IEEE Std 802.11h-2003  
(Amendment to  
IEEE Std 802.11-1999)

**AMENDMENT 5: Spectrum and Transmit  
Power Management Extensions in the  
5 GHz band in Europe**

**ISO/IEC 8802-11:2005/Amd.5:2006(E)**  
**IEEE Std 802.11h-2003**  
**(Amendment to IEEE Std 802.11-1999)**

Figure 27—Capability Information fixed field

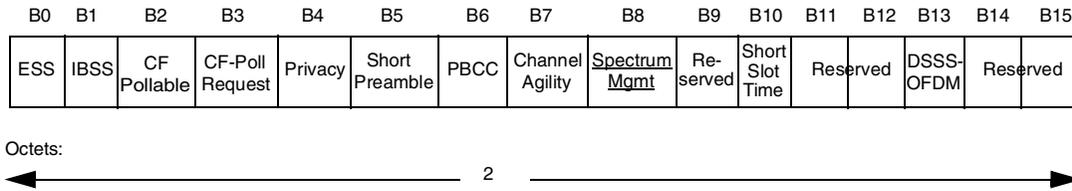
Change the contents of Figure 27 as shown:
